### APPEAL SUMMARY

**Appeal ID:** 22128

**Project Address:** 733 SW Oak St

**Building/Business Name:** Balfour Guthrie Building /  
Metropolitan Group (occupant)

A2A.2 PLAN - FIRST LEVEL  
1/4"=1'-0"

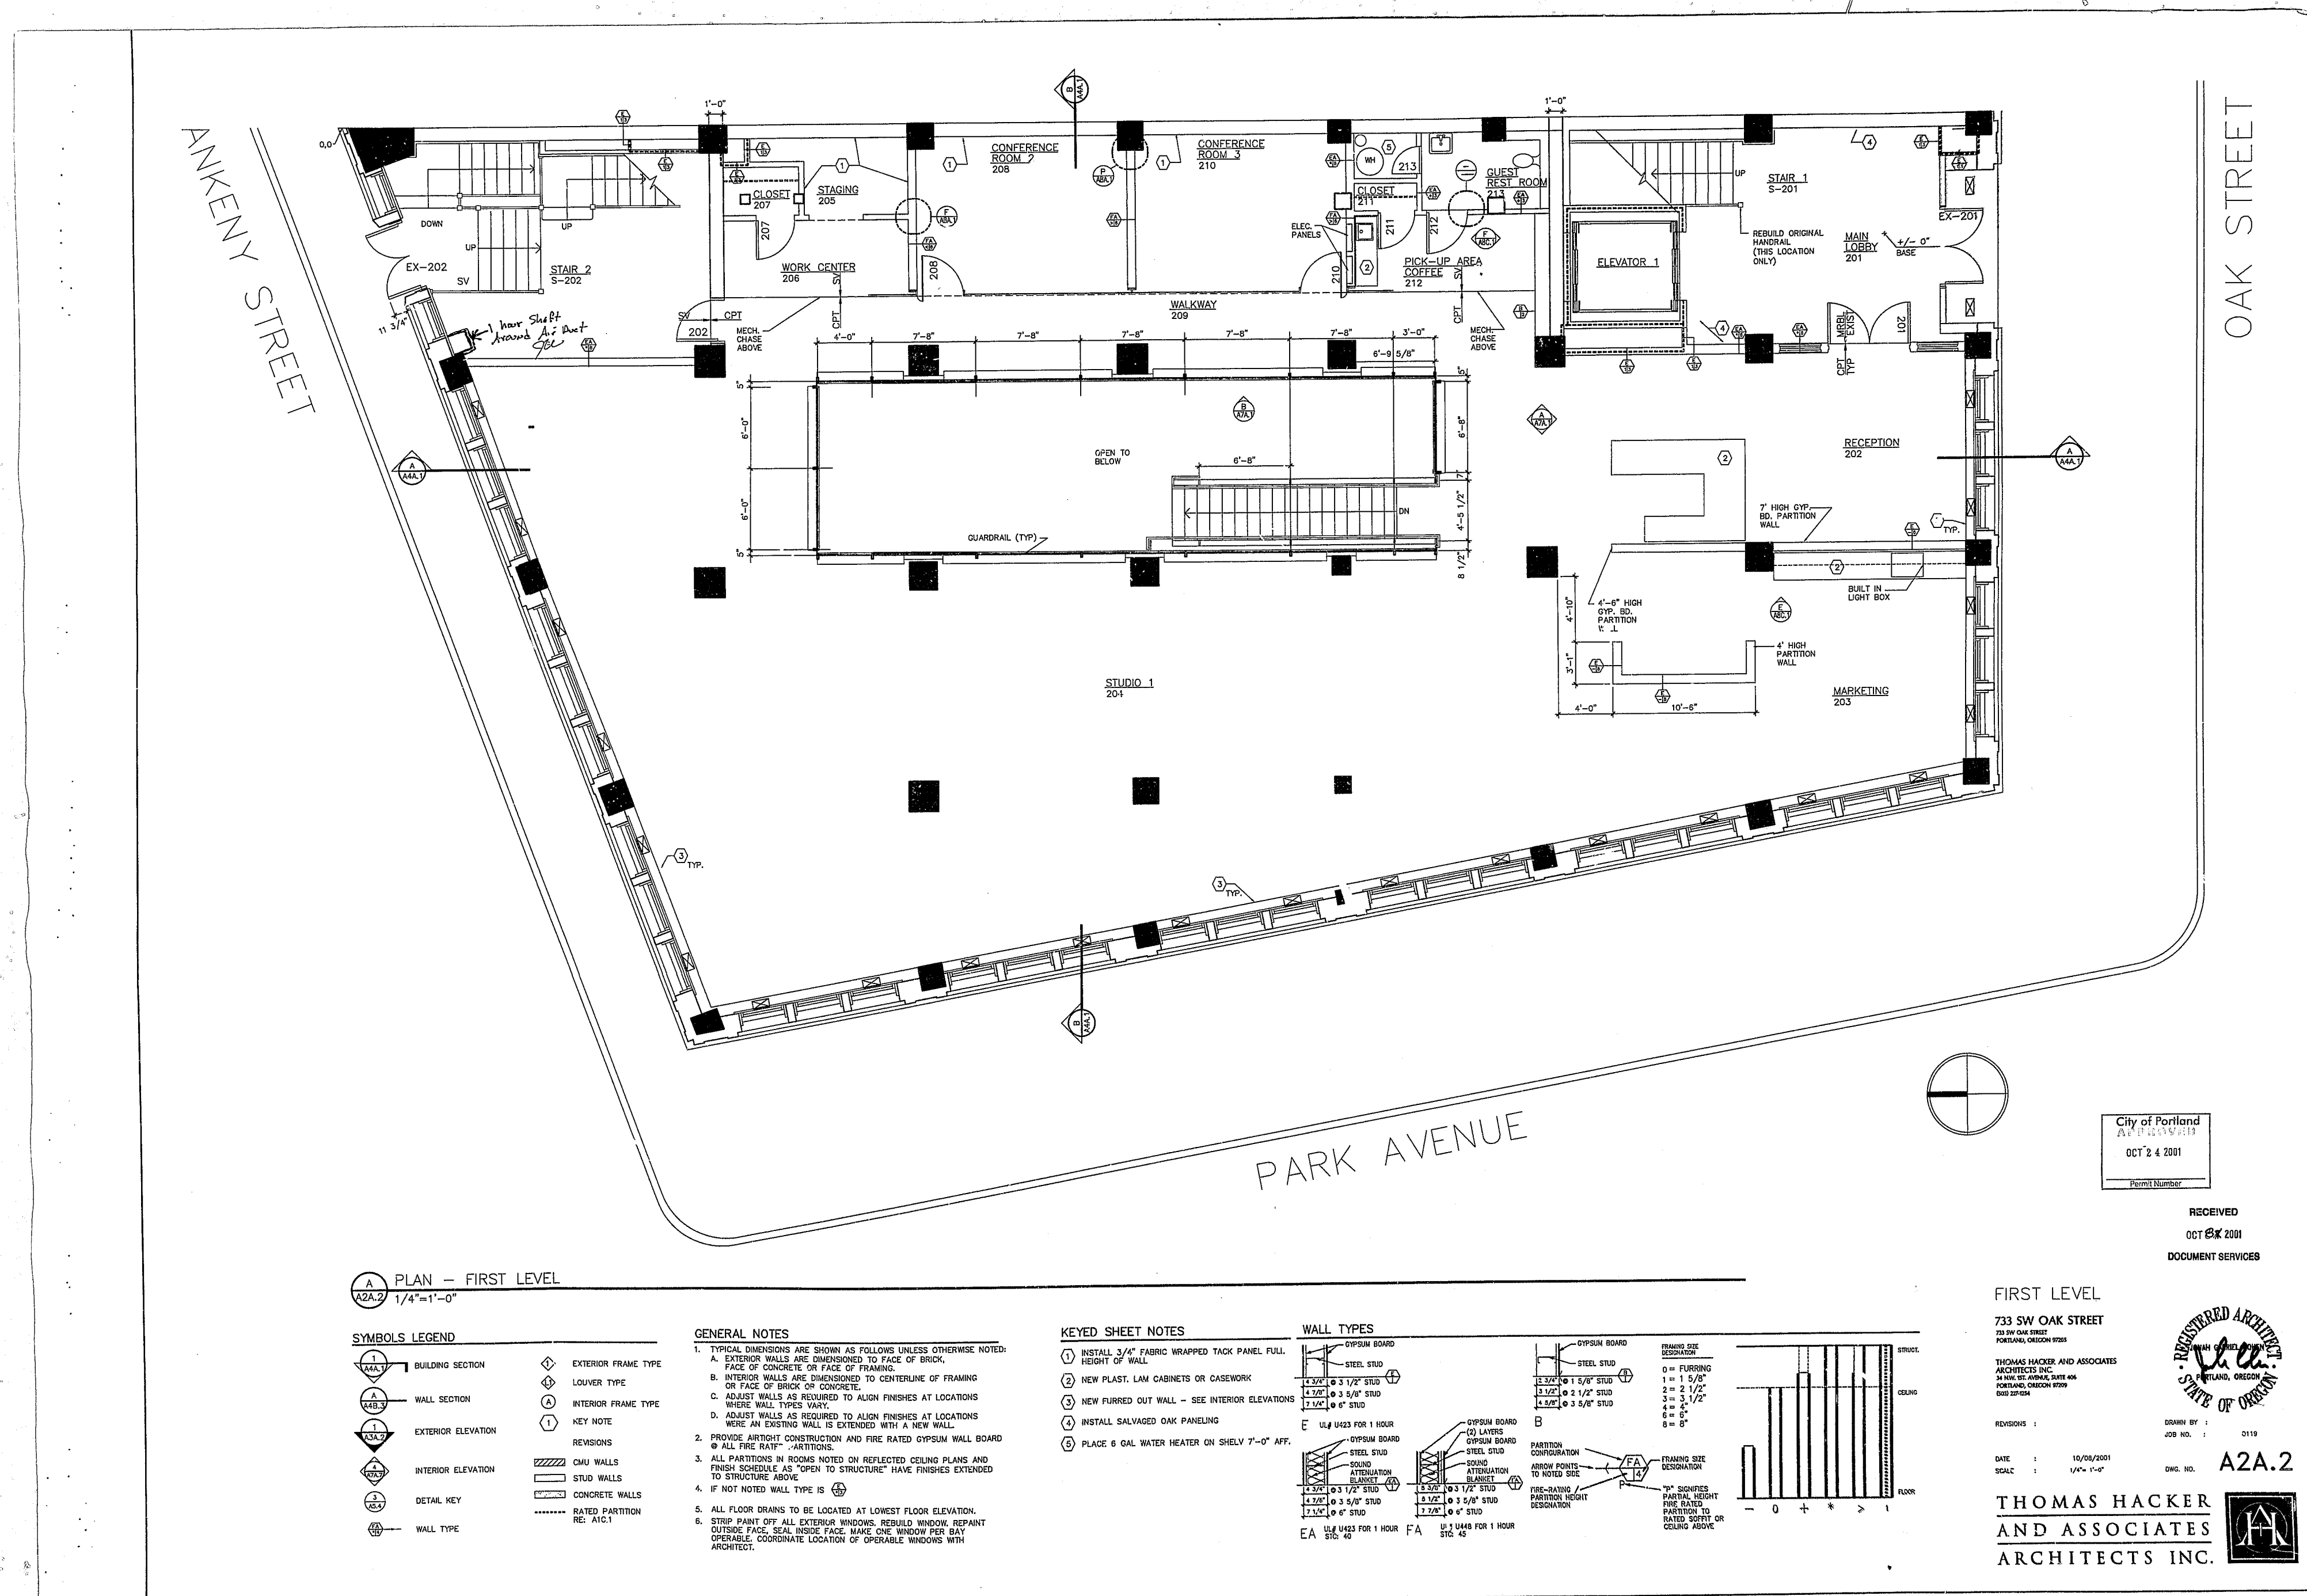
In planning the space attempts were made to locate the stair in a number of configurations that would give greater separation but these arrangements did not achieve the right functional relationships in the plan—primarily the route to the lower level conference room 1. We think that the openness of the plan and the stair and the position of the conference room (where guests are likely to be) create a safe arrangement. The functions at the ends of the greatest diagonal also have the least occupancy (1 or 2 in the model building area periodically and service personnel only in the mechanical room 120).

4. Separation of exits: **Granted provided** basement sprinkler system is maintained per the Fire Marshal's Office and building is provided with a smoke detection system per the Fire Marshal's Office.

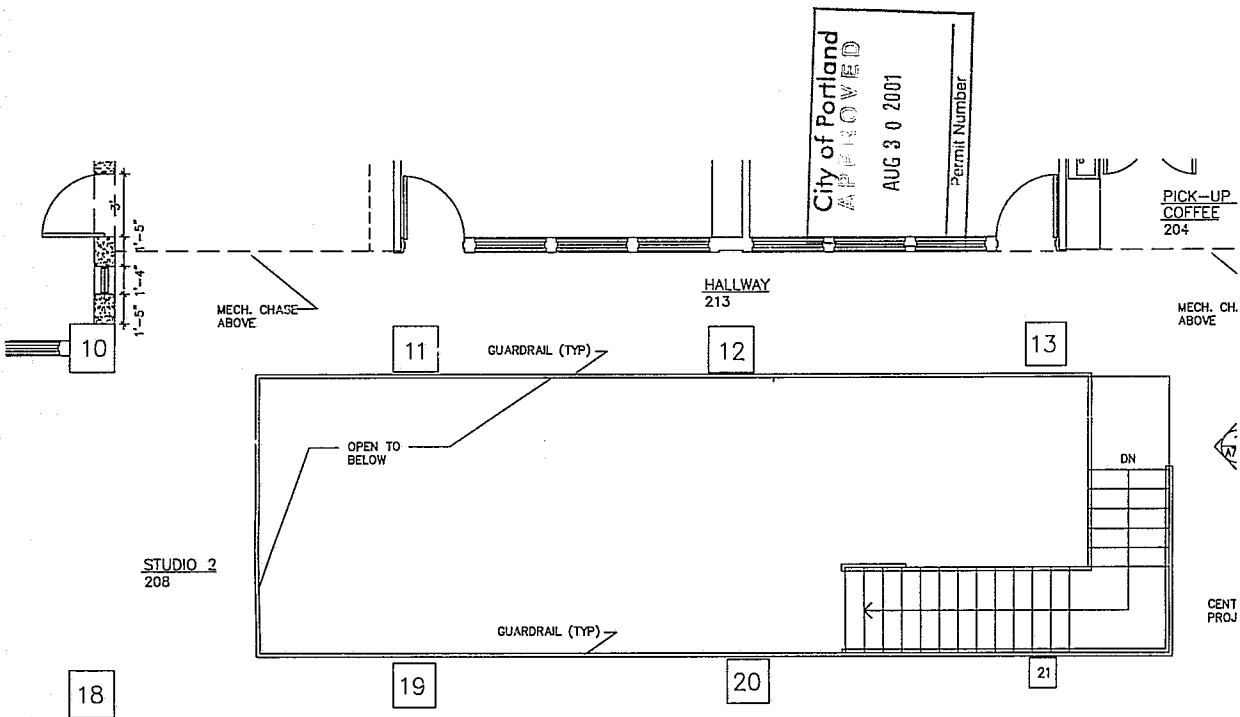
Item #	Location on plans	Code Section	Clarification / Comments
1.			Please provide a floor diaphragm design capacity for seismic. Even if this information is not in permit, it is still required for this permit.
2.			What effect will the removal of the structure at basement level have on the structure. Please provide a narrative.
3.			
4.			
5.			
6.			
7.			
8.			
9.			
10.

- Item 1 Calculation for the effect of the new opening in the first floor slab diaphragm is enclosed in pages R-1 thru R-4.
- Item 2 Steel columns are not part of the primary framing of the building and were added to support concentrated loads due to some equipment. The equipment and their pads have been removed; therefore, removal of these secondary columns does not seem to have any adverse effect on the structure.
